**Aquinas High School Addition
3420 Main Road
David City, NE**

ADDENDUM NO. 1-1

ADDENDUM

Addendum No.: 1

Ref. Sht #:
C110
 OCT 2012

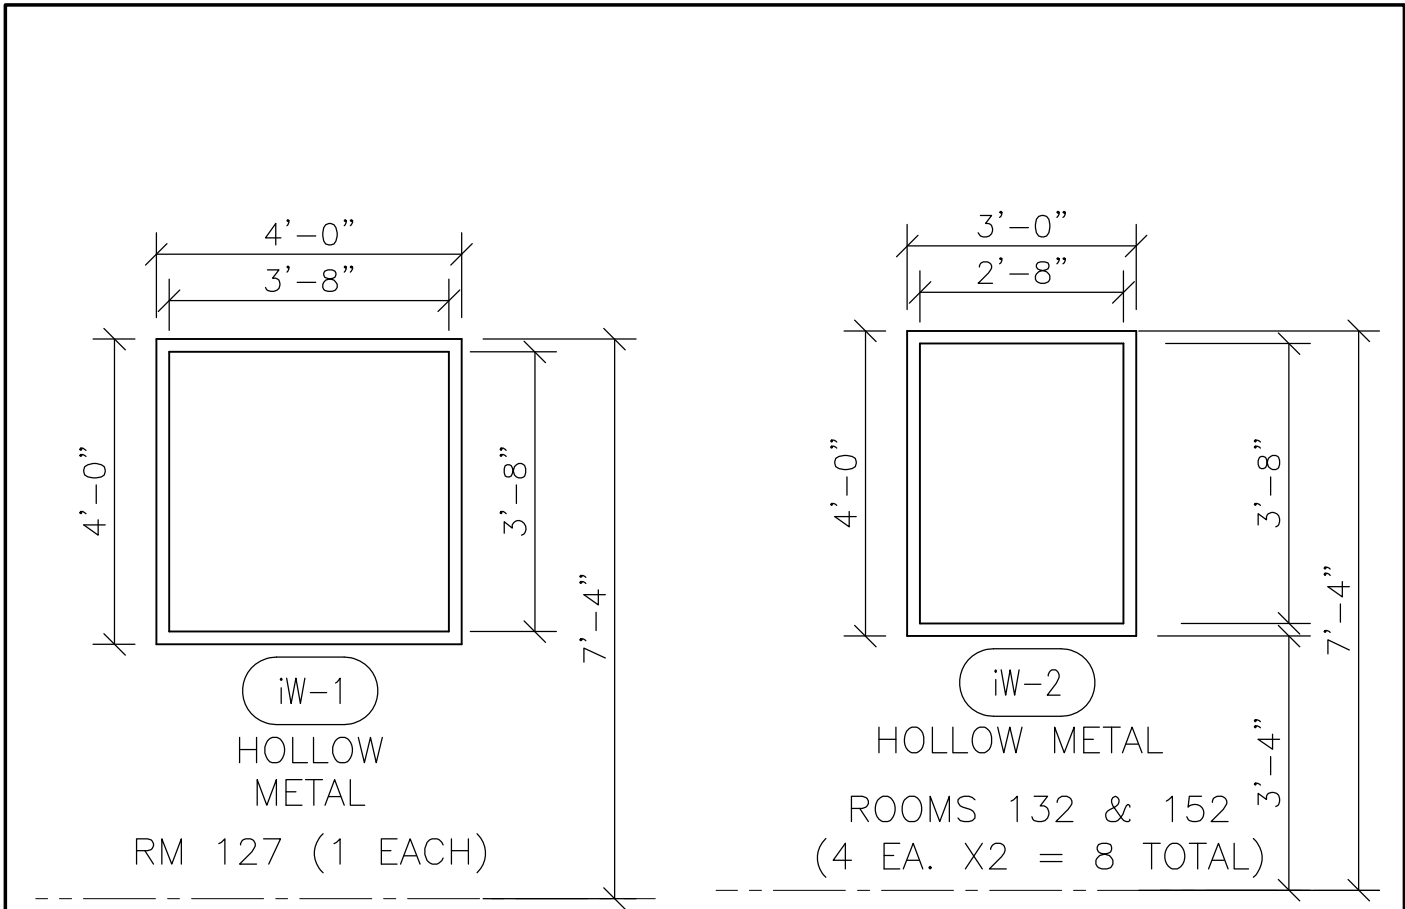
1. Reference Sheet C100, Site Demolition Plan and Notes.
 - A. Delete Sheet Note 2 and indication to remove (3) trees. Trees and root ball has been removed by Owner.
2. Reference Sheets C110 & C111, Site Plan.
 - A. Revise east pvc drain to north side of new storage building per Attachment “A”.
 - B. Revise south accessible parking to delete (2) ADA stalls and (1) ADA ramp and add concrete parking stalls with 6’ sidewalk per Attachment “B”.
 - C. Revise note 32.08 from “6” pvc” to “8” pvc.”
3. Reference Sheets C120, Site Grading Plan.
 - A. A potential borrow site for fill has been identified north of David City. See Attachment “D” for location of site and possible routes to the project site. Contact Mike Kozisek for fill purchase terms.

Ref. Sht #:
A800
 OCT 2012

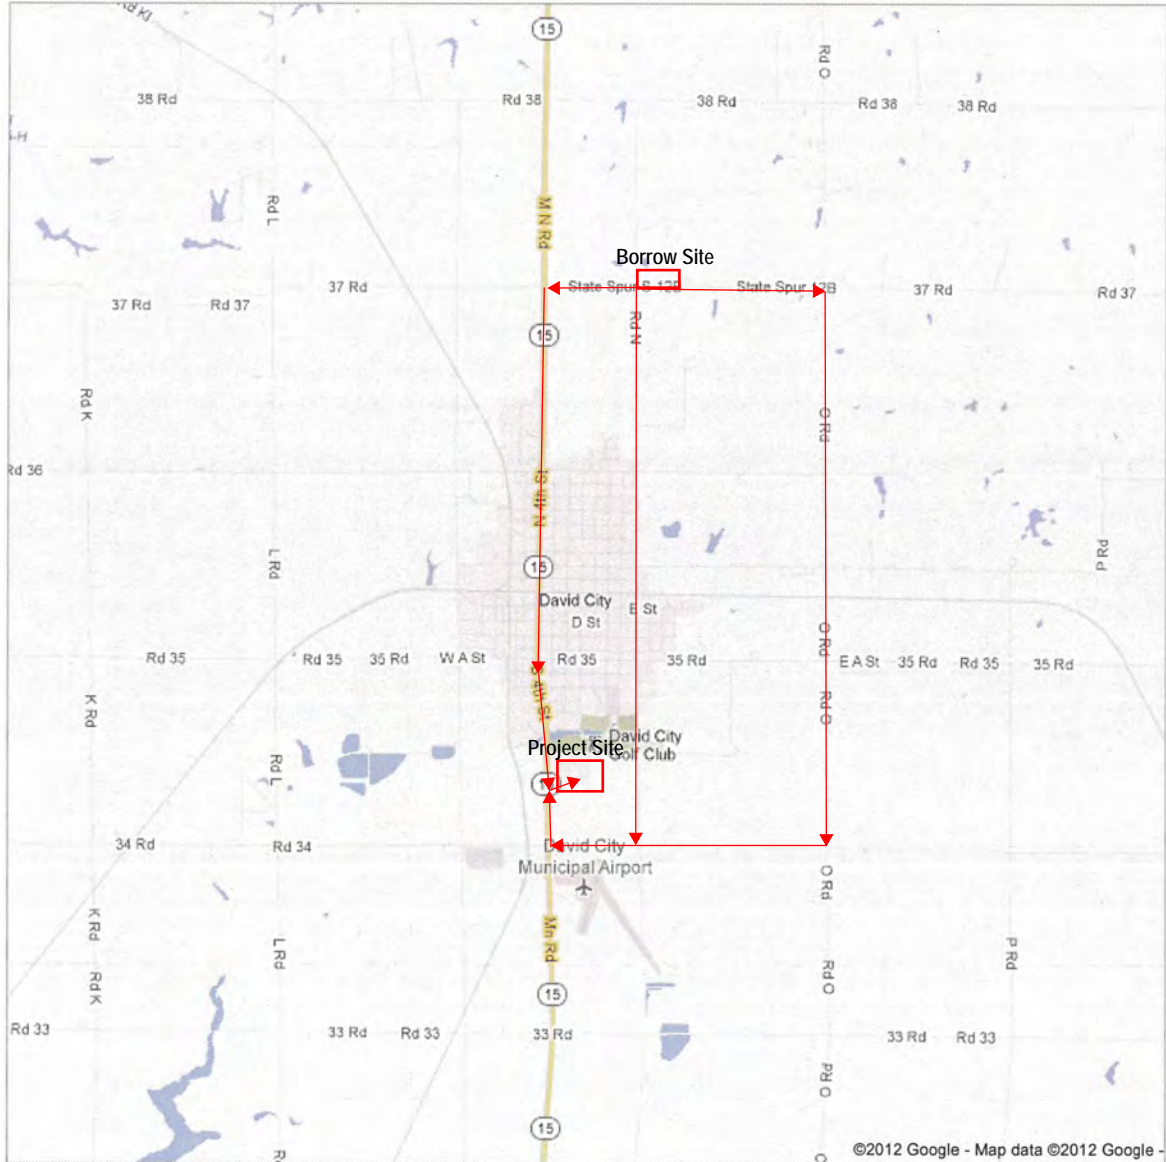
6. Reference Sheet A800, Door and Window Information.
 - A. Add Detail L11 (Attachment “C”), interior hollow metal windows. Add hollow metal windows indicated with tempered glass installed in masonry walls.

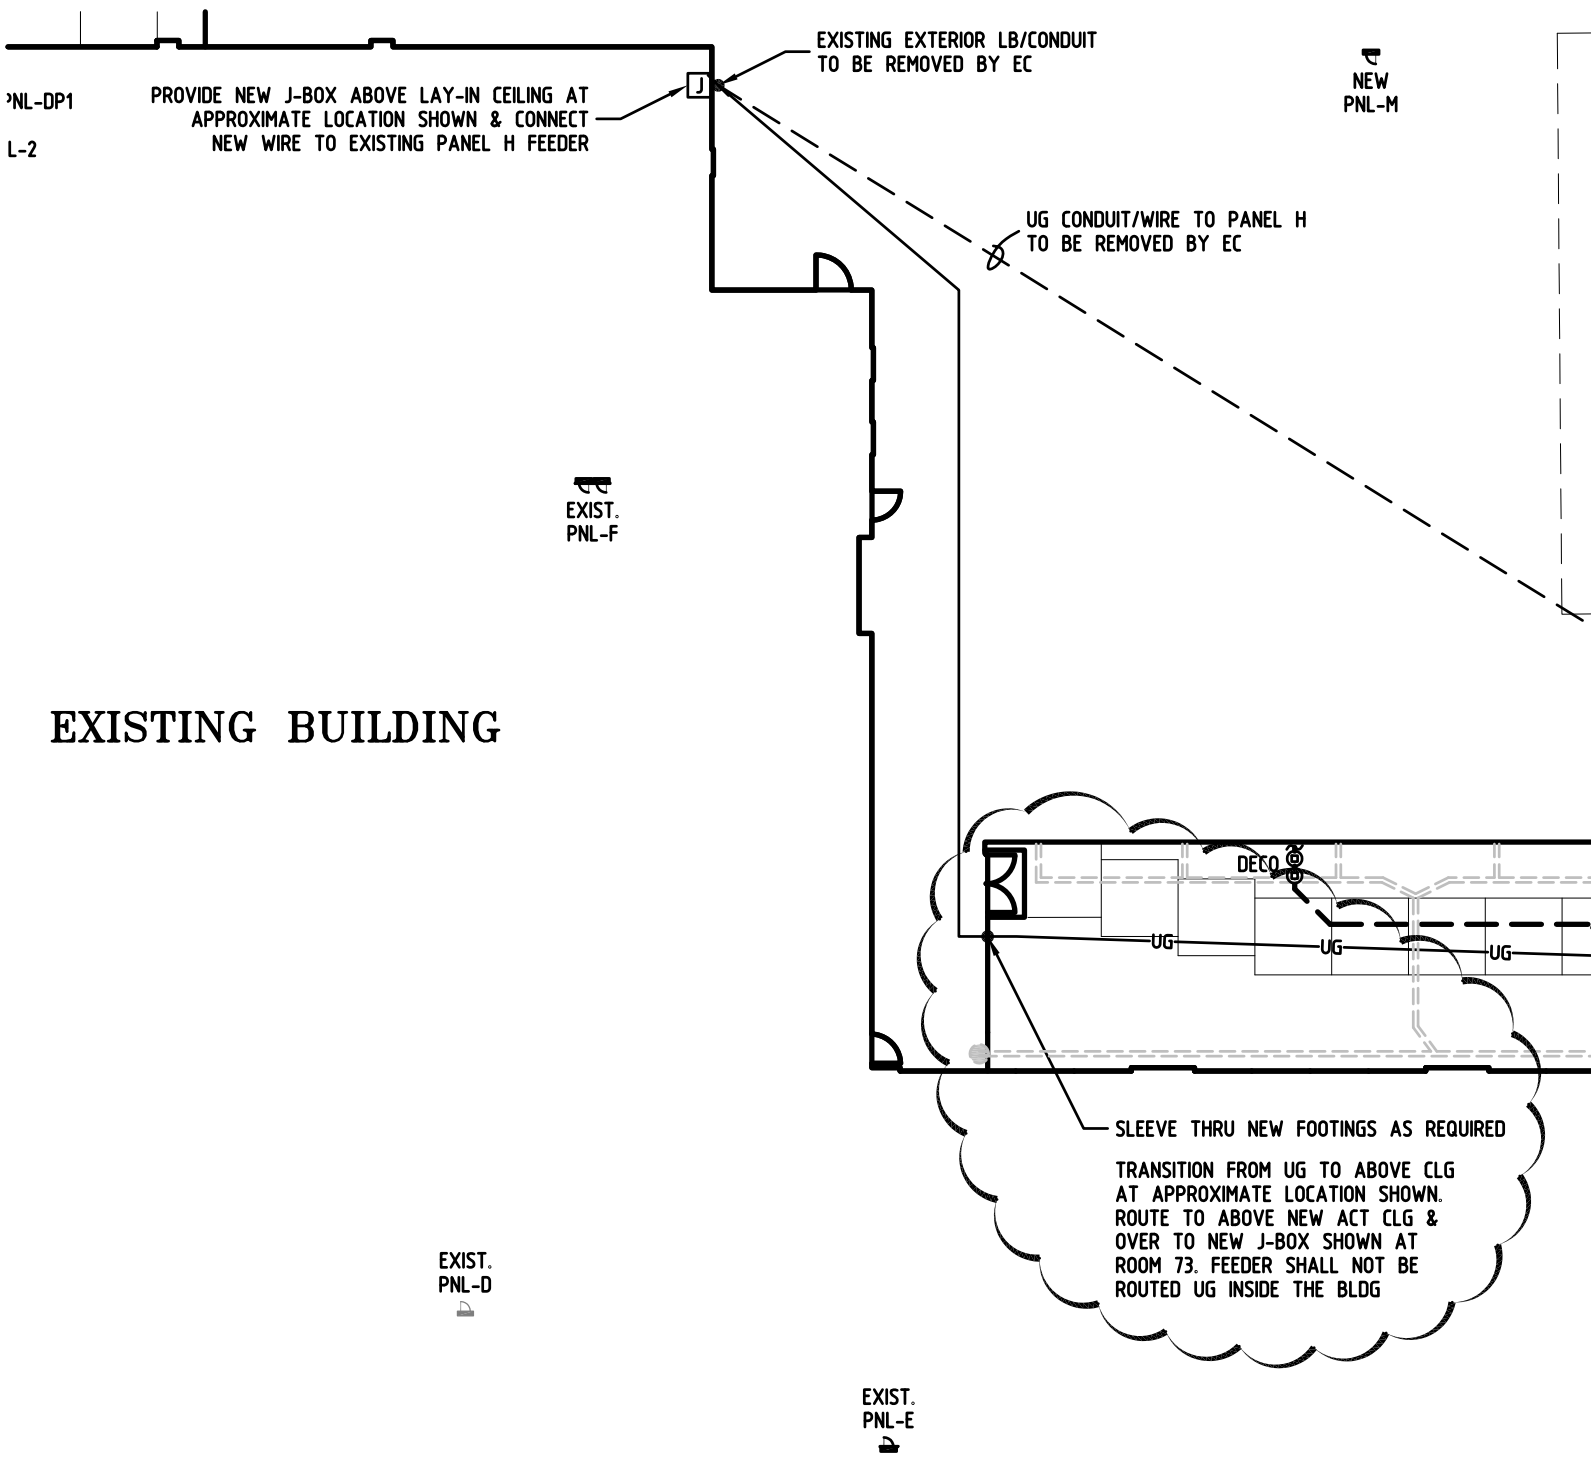
- 1) At Mechanical 140; add magnetic hold opens/smoke detectors at door 140A.
- 2) At Instr. Music 115; add electrical connection to 3.0kW 208V/1ph domestic water heater [DWH-4]. Provide Ste disconnect & connect to panel L with 2-#8 plus 1-#10gnd in ¾"C. Terminate to new 20/2 brkr. See attached drawing AD001.E201-1.
- 3) Keynote #8; cable trays shall 12"Wx2"D. New model #: Cablofil CF 54/300 [or equal].
- 4) Alternate E-3; provide 1-RG6 backbone connection between telecom closet 43 & telecom closet 120 & terminate to line taps.
- 5) Video surveillance; the contractor shall provide a box & conduit stub-out to accessible location only, with the exception of relocating one-1 existing camera. New cameras & wire by owner.

SHEET:
ME101
 AD001.ME101-1

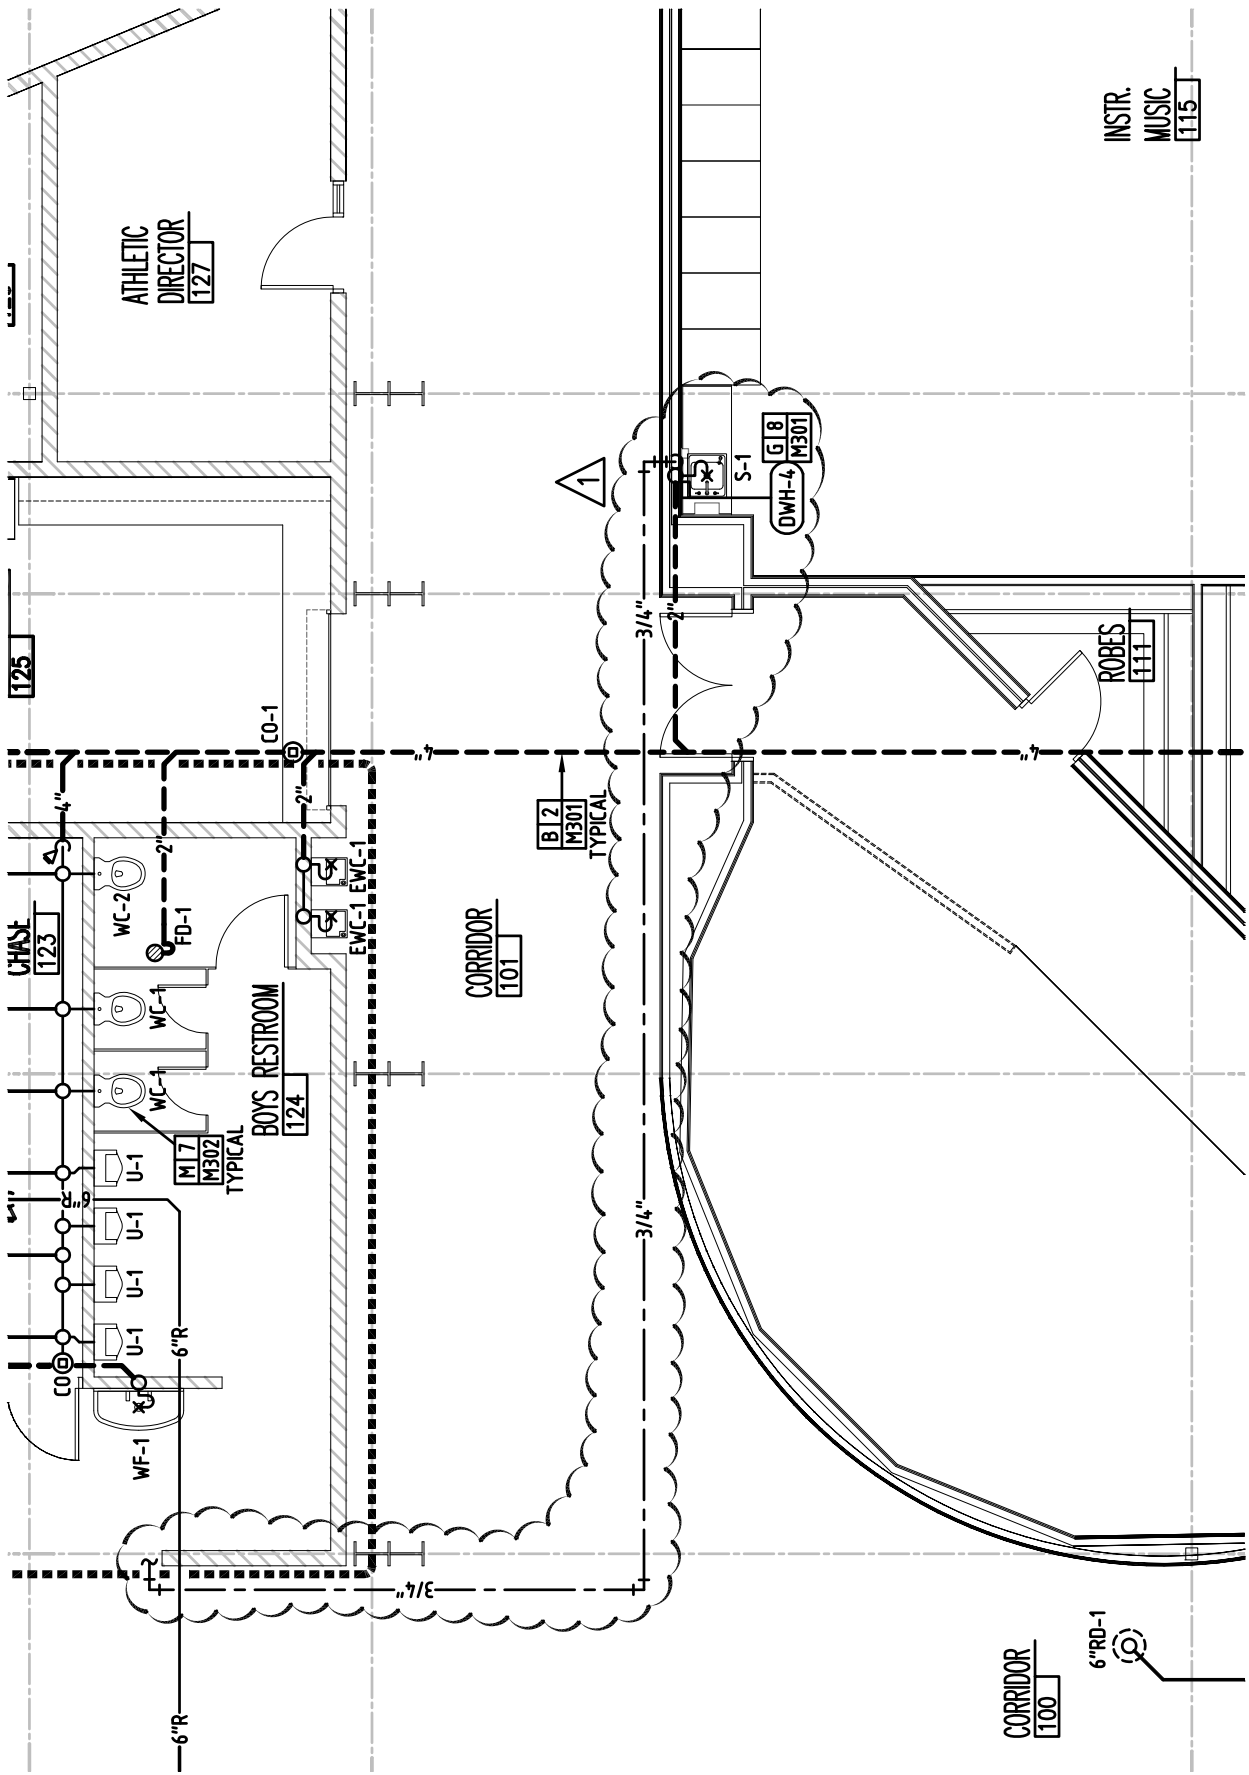
- 1) New panel H feeder; transition from underground to above ceiling at approximate location shown in Corridor 100 [adjacent new exterior double door]. Route to above new ACT ceiling & over to new j-box shown at room 73. Feeder shall not be routed underground inside the building. Existing exterior conduit at wall of room 73 shall be removed. See attached drawing AD001.ME101-1.

SHEET: **M101**
 AD001.M101-1

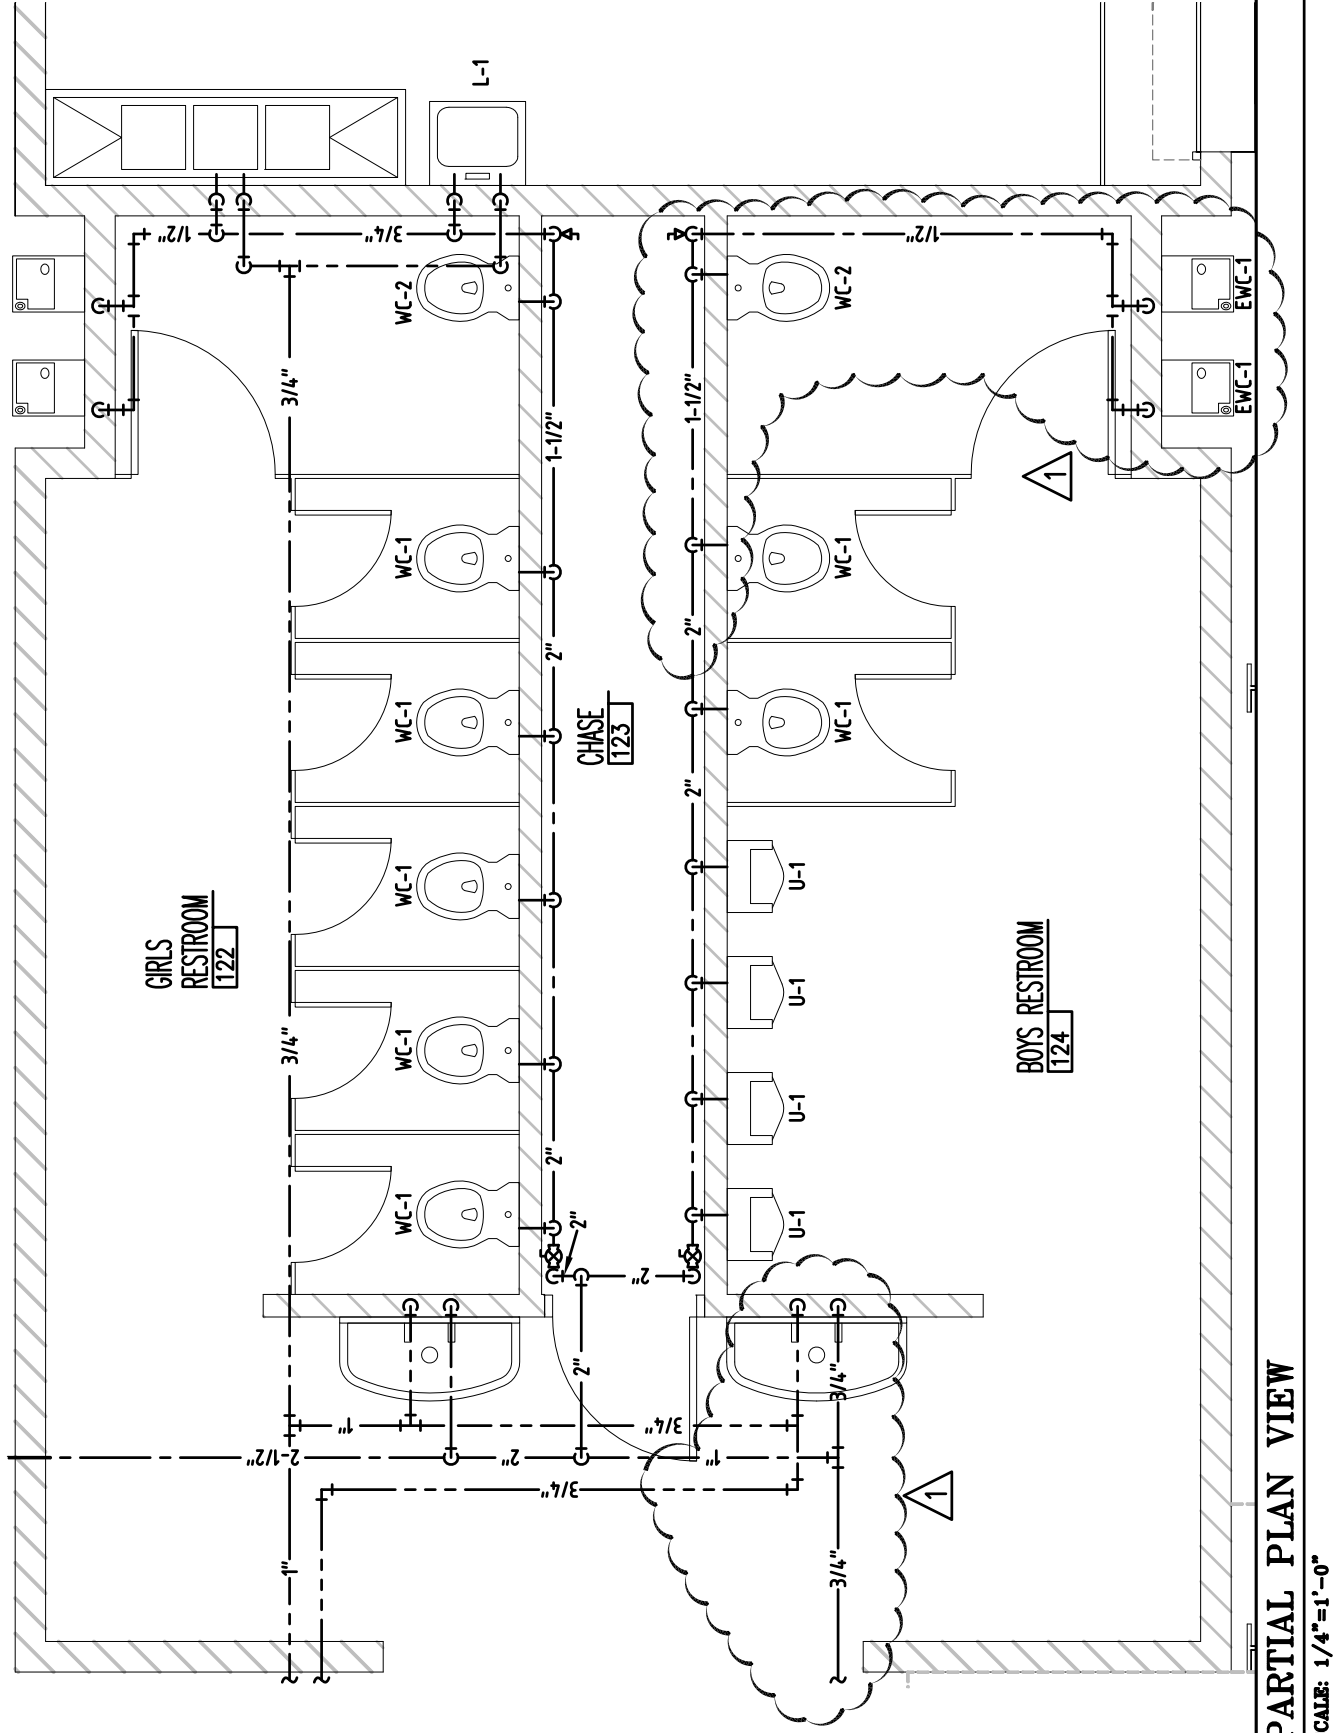
- 1) At Instr. Music 115, provide a new sink (S-1) in cabinetry in the northeast corner of the room. Extend 2" waste piping from sink to main waste line to the north. Extend 3/4" domestic cold water piping from Boys Restroom 124 to new sink location. Provide a new 3.0kW electric instantaneous water heater located under sink (S-1). Refer to attached supplemental drawings AD001.M101-1, AD001.M101-2, AD001.M301-1 & AD001.M301-2 for details.
